Access Compliance Report

Public Rights-of-Way

(Curb Ramps)

Intersection ID: 53339	Main Street: NORTHLAKE CENTRE PY	Cross Street: CALHOUN ST	Location: NE
ADA ID: DA002E5F00DB	Ramp Type: Perp	Initial Pass/Fail: Fail	Overall Compliance: No
Severity Score: 10			
Codes/Mitigation Info/Possible Solution		Field Measurements/Component Compliance

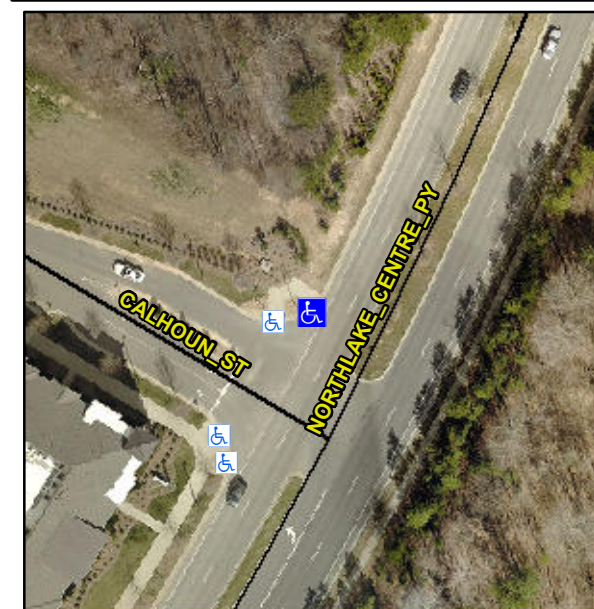
R304.5.1, R304.5.3

Compliance	Description	Data	Compliance	Description	Data
N/A	Ramp Length (in)	96.0	Yes	Ramp Slope (%)	5.9
No	Ramp Width (in)	46.0	No	Ramp XSlope (%)	2.2
N/A	Flare Type LT	N/A	N/A	Flare Type RT	N/A
N/A	Flare Slope LT (%)	N/A	N/A	Flare Slope RT (%)	N/A
N/A	Flare Traversable LT?	N/A	N/A	Flare Traversable RT?	N/A
N/A	Landing Length (in)	N/A	N/A	DWS Provided?	N/A
N/A	Landing Width (in)	N/A	N/A	DWS Contrast?	N/A
N/A	Landing Slope (%)	N/A	N/A	DWS Length (in)	N/A
N/A	Landing X Slope (%)	N/A	N/A	DWS Full Width?	N/A
N/A	Landing Curb? (Y/N)	N/A	N/A	DWS Offset (in)	N/A
N/A	Shared Landing?	N/A			
N/A	Gutter Ponding?	N/A	N/A	Gutter Slope (%)	N/A
N/A	Gutter Lip Ht (in)	N/A	N/A	Gutter X Slope (%)	N/A
N/A	Painted X Walk1?	No	N/A	Painted X Walk2?	N/A
	X Walk 1 Direction	To SE		X Walk 2 Direction	N/A
N/A	X Walk 1 Width (in)	N/A	N/A	X Walk 2 Width (in)	N/A
	X Walk 1 Slope (%)	1.7		X Walk 2 Slope (%)	N/A
	X Walk 1 X Slope (%)	0.7		X Walk 2 X Slope (%)	N/A

Remove & Replace Entire Ramp.
